SI B18 06 12
Exhaust Systems

Voluntary Emissions Recall Campaign 11E-A03: Replace the SCR Mixer

E70 and E90 with the M57Y engine

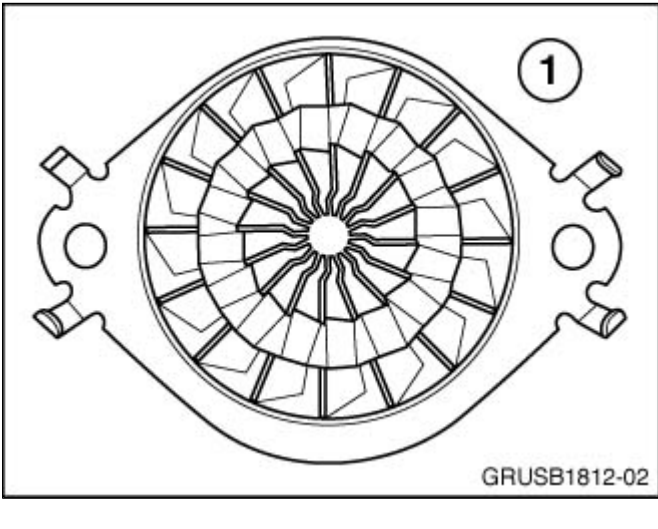
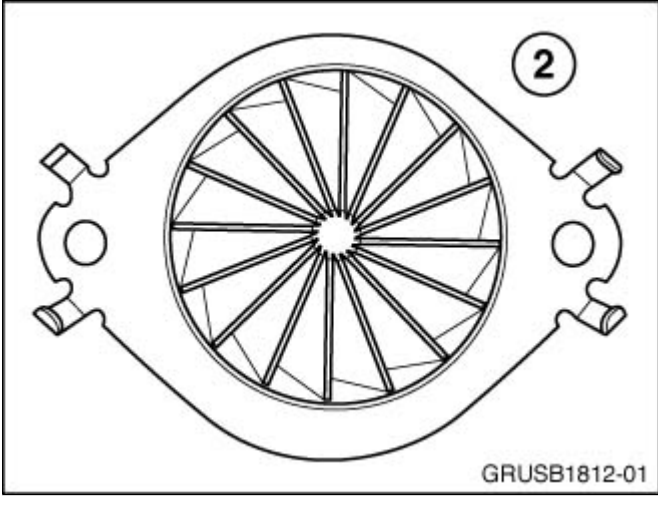
<p>GRUSB1812-02</p>	<p>The original style mixer has a multiple fin arrangement (1). This mixer will need to be replaced with P/N 18 30 8 513 445 (E70) or P/N 18 30 8 512 438 (E90).</p>
 <p>GRUSB1812-01</p>	<p>The updated mixer has one set of fins (2).</p>
	<p>The mixer for the E90 (1) is shorter than the mixer for the E70 (2).</p>

Replace the mixer (Repair instruction 18 31 140).

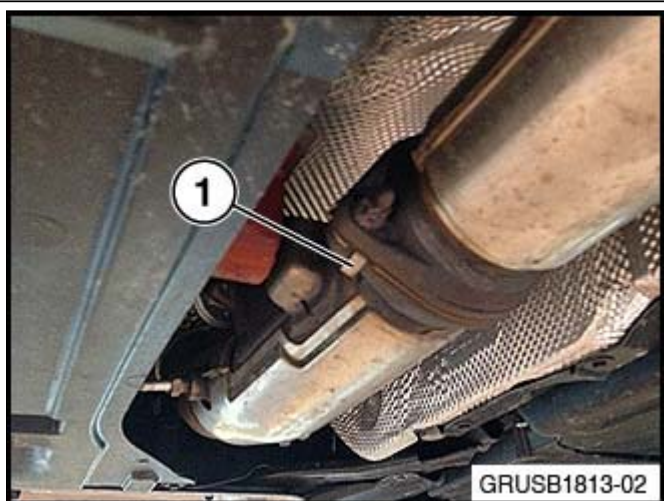
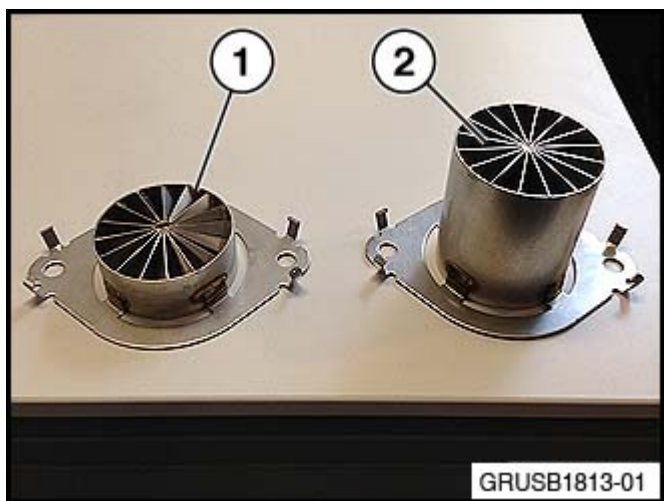
The barrel of the E70 mixer points toward the front of the car. This is easily identified by the mixer tabs wrapped around the front pipe flange (1).

The barrel of the E90 mixer points toward the rear of the car. This is identified by the mixer tabs wrapped around the flange on the SCR cat (1).
